This Service Information bulletin supersedes SI M11 03 08 dated **July 2008**.

Turbocharger Failure - Oil Supply Line Blockage

Protective cover (1)

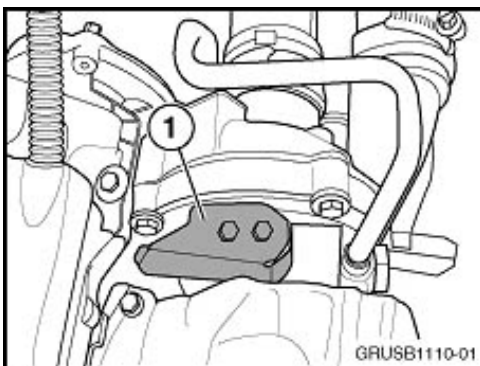
Upon replacement of the turbocharger assembly, always remove and inspect the oil supply lines for blockage or restriction. Ensure that the lines are not collapsed or kinked. Replace the lines if a blockage or restriction is detected. Inspection of the oil supply lines will avoid repeated failure of the turbocharger assembly. In addition, a protective cover should be installed on the supply line, as seen in the illustration below.
